Subject: Scholls Ferry Apartments (PA2024-00129)

PRE-APPLICATION CONFERENCE MEETING SUMMARY NOTES

Prepared for Scholls Ferry Apartments PA2024-00129, March 6, 2024

PRE-APPLICATION MEETING TRANSPORTATION RESPONSE

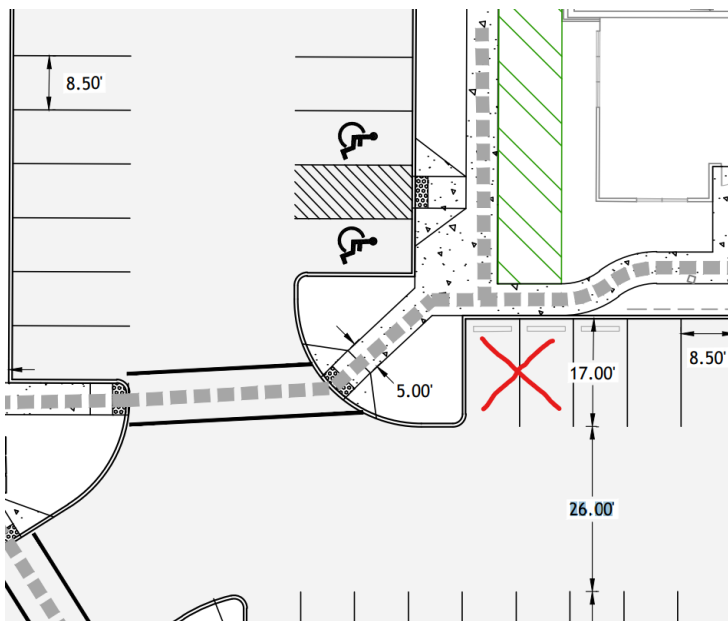
☒ Walkways that border perpendicular parking spaces shall be a minimum 7-ft wide unless concrete wheel stops, bollard, curbing, landscaping or other improvements are provided to prevent parked vehicles from obstructing the walkway (BDC 60.55.25.10.E).

This requirement was discussed during the meeting in relation to a couple of different areas of the parking lot. Staff highlights the following that wasn't raised during the meeting:

In the diagram shown above, (at least) the two parking stalls shown crossed out will be reduced in depth to 17-ft. This is allowed pursuant to BDC Section 60.30.15 (Note 6). However, BDC Section 60.55.25.10.B.5 states that:

“Walkways shall be paved and shall maintain at least 5-ft of unobstructed width. Walkways bordering parking spaces shall be at least 7-ft wide unless concrete wheel stops, bollards, curbing, landscaping, or other similar improvements are provided which prevent parked vehicles from obstructing the walkway.”

The resulting stall length will therefore result in a portion of the parked vehicles in the noted spaces to extend into the drive aisle, resulting in potential vehicle circulation conflicts. In this case, the applicant is advised that the walkway abutting at least the two stalls noted above will need to be widened to the 7-ft width mentioned above, wherein, the concrete wheel stops can be eliminated and allow for vehicles to be parked without extending into the drive aisle.
